# NTUA Headquarters Complex Office Building

Dyron Murphy Architects Project No. 2015.05

## ADDENDUM No. 1

October 27, 2016

**MECHANICAL OVERALL 1st FLOOR HVAC PLAN**

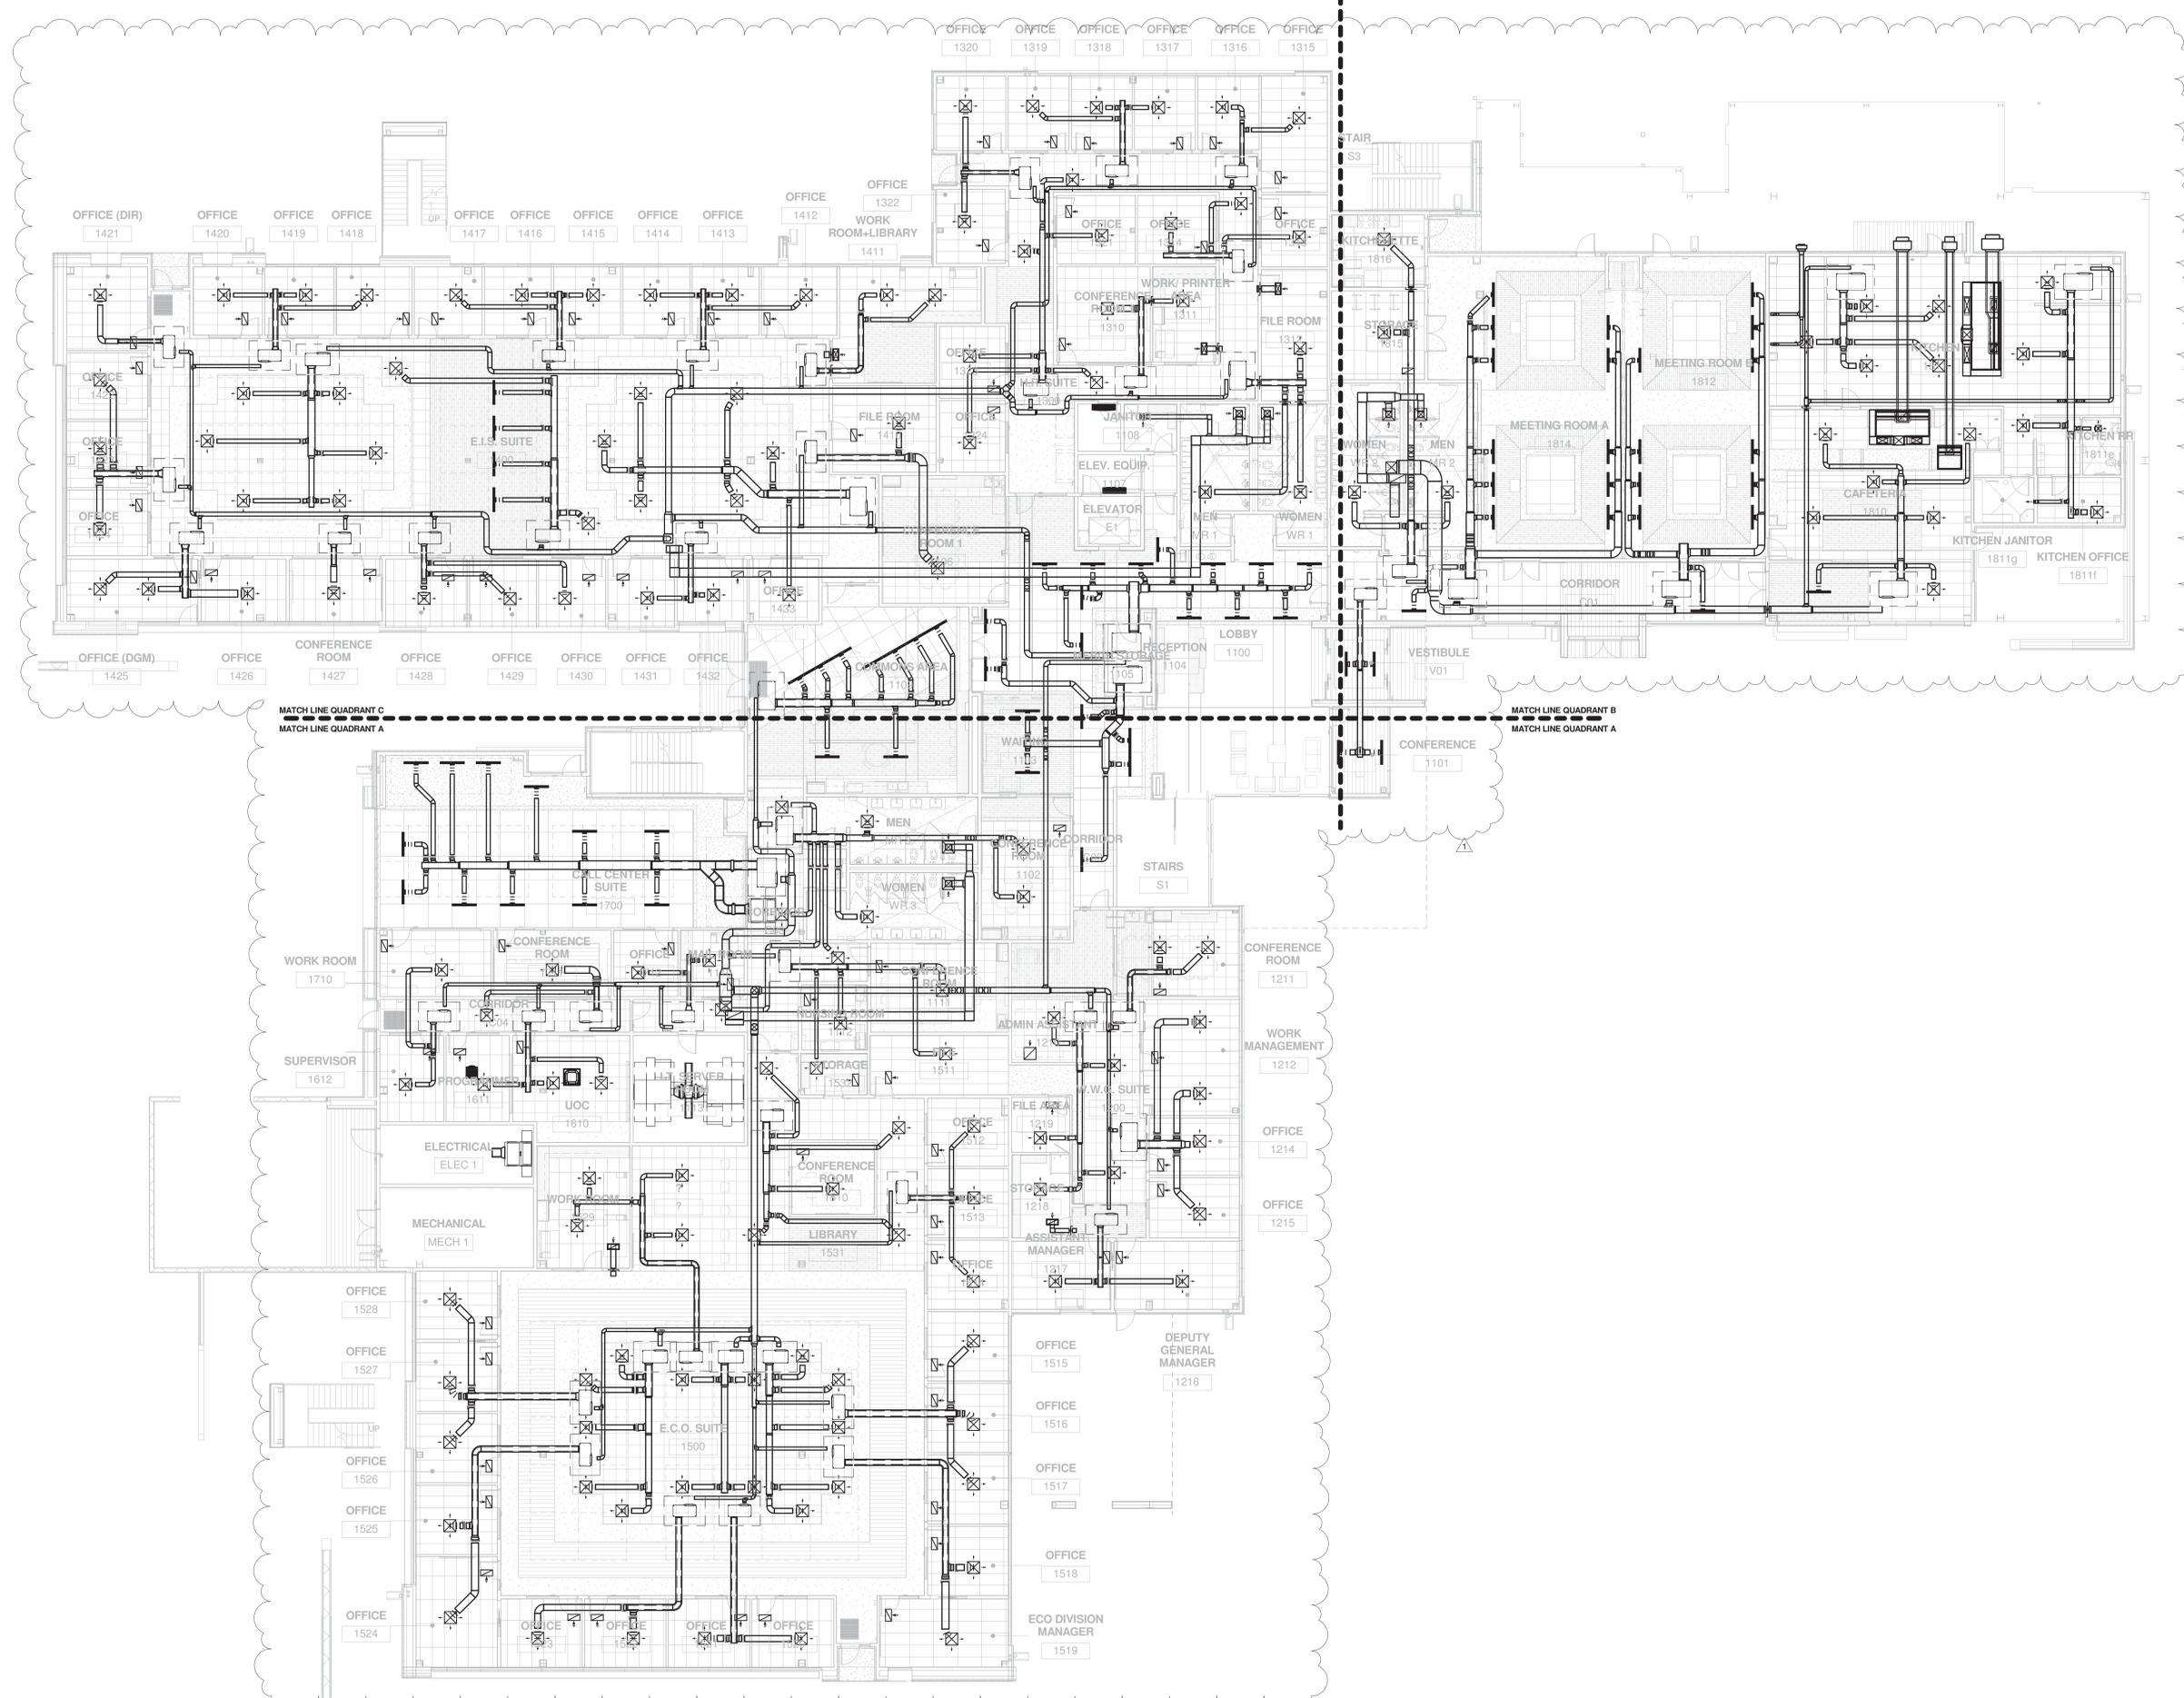
DOCUMENT:	DESCRIPTION:
Drawing M003 MECHANICAL EQUIPMENT SCHEDULES	- ADDS: Water-side Economizer to be included with Water-Source-Heat-Pump (WSHP'S) Units: Sizes: 2ton, 2.5ton, 3ton, 3.5ton, 4ton, 5ton and 6ton.
Drawing M101 MECHANICAL OVERALL 1 <sup>st</sup> FLOOR HVAC PLAN	- REVISES: Outdoor Air Ventilation ductwork sizes & cfm capacities.
Drawing M101a MECHANICAL 1 <sup>st</sup> FLOOR HVAC PLAN – QUADRANT A	- REVISES: Outdoor Air Ventilation ductwork sizes & cfm capacities.
Drawing M101b MECHANICAL 1 <sup>st</sup> FLOOR HVAC PLAN – QUADRANT B	- REVISES: Outdoor Air Ventilation ductwork sizes & cfm capacities.
Drawing M101c MECHANICAL 1 <sup>st</sup> FLOOR HVAC PLAN – QUADRANT C	- REVISES: Outdoor Air Ventilation ductwork sizes & cfm capacities.
